## AMENDMENTS TO THE DRAWINGS

Dong-Ho LEE  
 STACK PACKAGE MADE OF CHIP SCALE PACKAGES  
 Attorney Docket No. 9903-074/Application No. 10/750,979

Annotated Sheet Showing Changes

**FIG. 3**

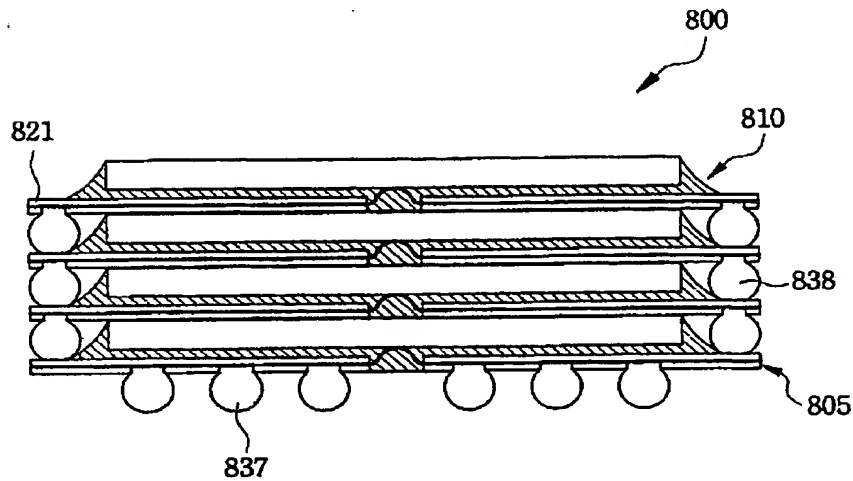
The drawings are objected to as failing to comply with 37 CFR 1.84(p)(5) because they include the following reference characters not mentioned in the description: 821 and 838 of FIG. 3, 151-152, 167, 171, 175, 183 of FIG. 4.

The specification has been amended to properly identify the reference characters in FIGS. 3 and 4.
